Memo

TO: Public Safety Committee
FROM: Ed Andrews, PE
Public Works Director
SUBJECT: Westgate Road Review
DATE: April 12, 2017

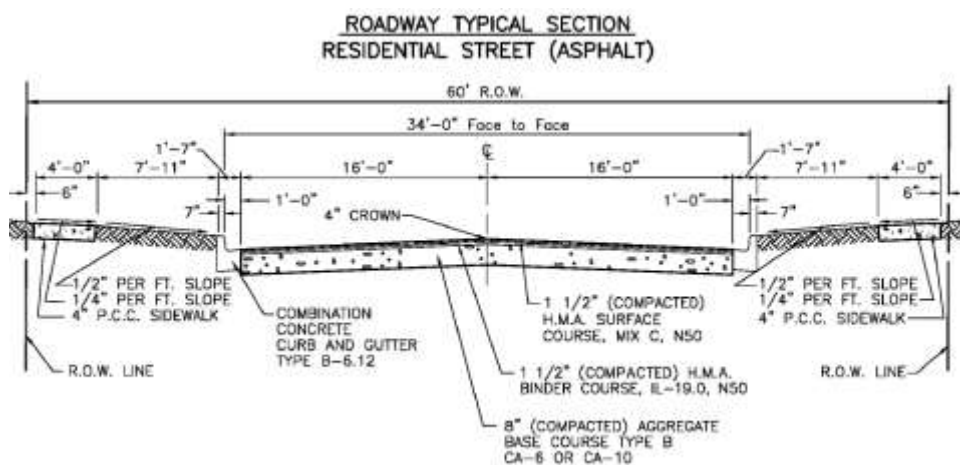
Traffic volumes along Westgate vary, ranging from 3050 AADT (Average Annual Daily Traffic) at its south end to 1900 AADT at its north end. These volumes, coupled with connectivity to other higher functional classification roadways contribute to Westgate Road's designation as a Major Collector.

Google Earth Street View facing north towards Devonshire

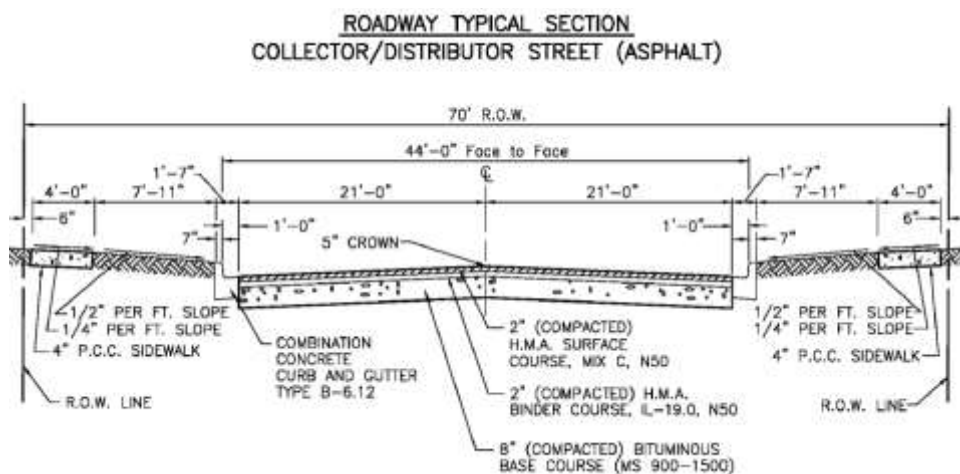
Sidewalks also generally adhere to this standard, but a portion were constructed at the back of curb beginning just east of Stratford Drive to Devonshire Road.
